Service Information Bulletin

Advanced Notice of Recall 08V-111

Subject: Technical campaign, Wheel-bearing check

Model: G 650 Xcountry, G 650 Xchallenge (K15)

Fig 1: Left rear wheel-bearing guide

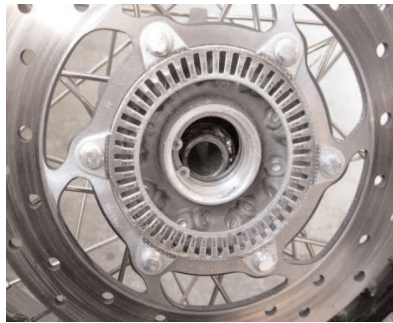
Details: Some G 650 Xcountry and G 650 Xchallenge motorcycles left the factory with the wrong circlip (Figure 2) installed on the left-hand side of the rear wheel-bearing guide (Figure 1). The result can be that this circlip rubs against the spacing bushing. The particles of metal removed by friction can penetrate the wheel bearing and cause failure. There is also the possibility of incorrect sensor signals causing the ABS to malfunction. If this happens the ABS warning light comes on, alerting the rider to the situation. Even under these circumstances, the brakes remain fully available to slow the motorcycle.

Aftersales Solution: Please check your entire stock of motorcycles in the range of VINs affected, starting with a Vehicle History Check, and make sure that every motorcycle is fitted with the correct circlip.

If you find that the wrong circlip is installed, the spacing bushing, both wheel bearings, the circlip and both shaft sealing rings have to be replaced.

Fig 2: Wrong circlip

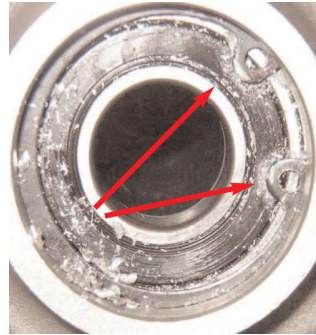
The distinguishing feature between the two circlips is the shape of the lugs for the eyes that engage the tips of the circlip pliers. The correct circlip is distinguished by the inward-facing flats on these lugs (see Figure 3); whereas the wrong circlip has rounded lugs (see Figure 2).
